Re: Board of Zoning Adjustment Case No. 19377
The Boundary Companies and the Missionary Society of St. Paul the Apostle (the "Applicant")
3015 4th Street, NE (Square 3648, Lots 1070 and 1071) (the "Application")

Board of Zoning Adjustment
District of Columbia
CASE NO.19377
EXHIBIT NO.99

Ex. 64A5, Sheet B-3 (“Site Plan”)

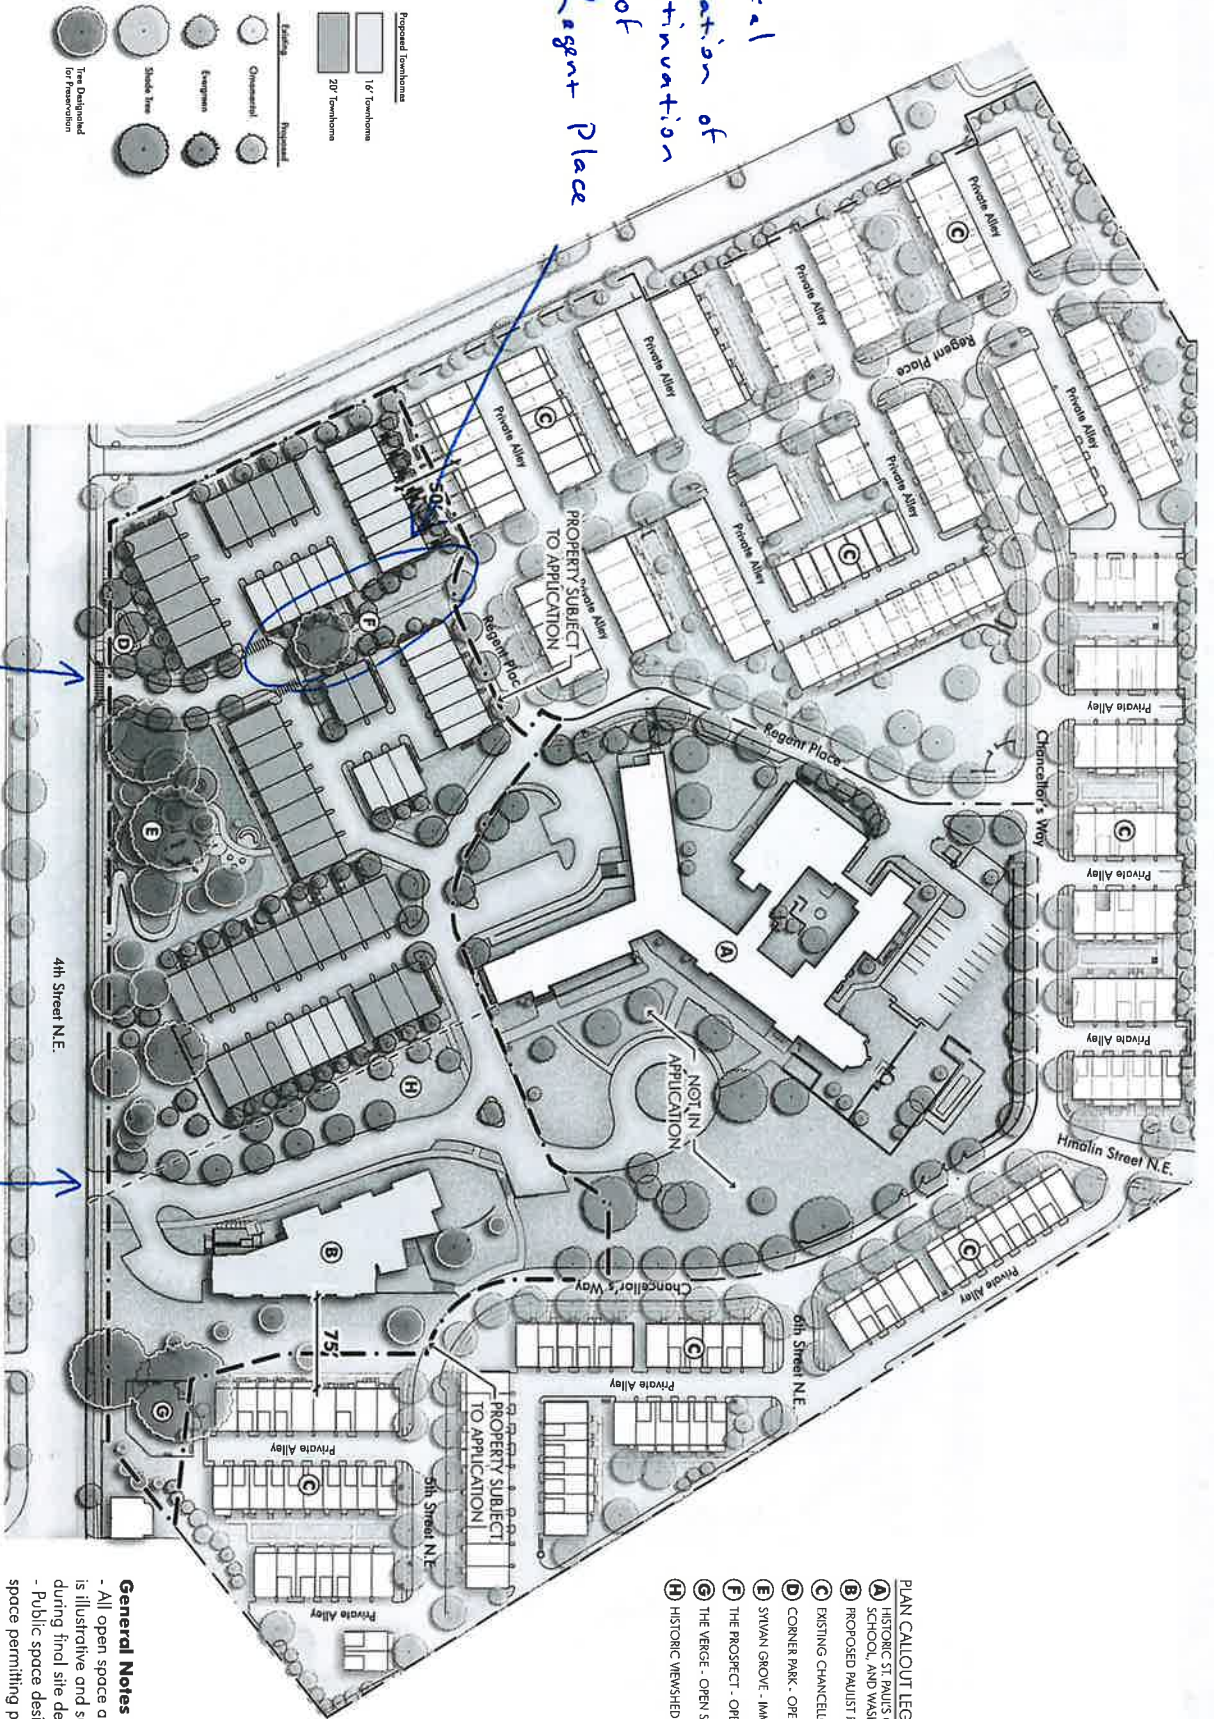
If the Applicant is allowed to construct its system of “private streets” it can, and likely will, restrict access to its residents and their guests, and will prohibit access on the “private streets” to the school students and their parents¹. For example, a person attempting to access the school from the north or east, cannot access the school from 4th Street using the proposed “private street” shown on the Site Plan that meets 4th Street (adjacent to the (D) shown on the Site Plan). Instead that person would be forced to access the school using only the circuitous driveway shown on the Site Plan further to the south (adjacent to the new Paulist Building labeled with the (B) on the Site Plan). Not only is this route inconvenient, but it forces pedestrians and cars to share the same access point.

Another adverse effect of the Project is that it completely encircles the school so that the only vehicular access is via the existing driveway (with a relocated and widened entrance). While this continues the status quo, there is a tremendous opportunity here to implement a more reasonable traffic pattern for access to the school building by allowing a public access easement for traffic on the “private street” shown on the Site Plan adjacent to the (D). The current driveway creates a dangerous traffic situation when vehicles and pedestrians are forced to access the school through the same choke point. The design of the driveway is a legacy of the encirclement of the School by the existing EYA/Chancellor’s Row development that was approved as a PUD about ten years ago. I urge that the Board not make the same mistake² again.

Finally, given DDOT’s comments regarding East-West connectivity, one wonders why the Applicant’s site Plan chose to locate “The Prospect” (adjacent to the (F) on the Site Plan) in what is the obvious location for a continued roadway making a potential East-West connection with Regent Place. It appears this was calculated to prevent use of Regent Place for exactly the kind of east-west connectivity between 4th and 7th Streets that DDOT calls for in its report.

Logical
Continuation of
of
Regent Place

St. Paul's Townhomes
Site Plan
"Private Street"

School driveway entrance

I think two of the mitigations recommended by DDOT in its report are critical to allow necessary pedestrian and vehicular access to the school. They are:

- Provide 6-foot wide sidewalks adjacent to all private streets, including the driveway extending from 4th Street NE to Regent Place NE; with adequate landscape strips and/or pedestrian buffers, subject to DDOT's approval;
- Provide public access easements spanning the extent of all private streets and associated sidewalks;
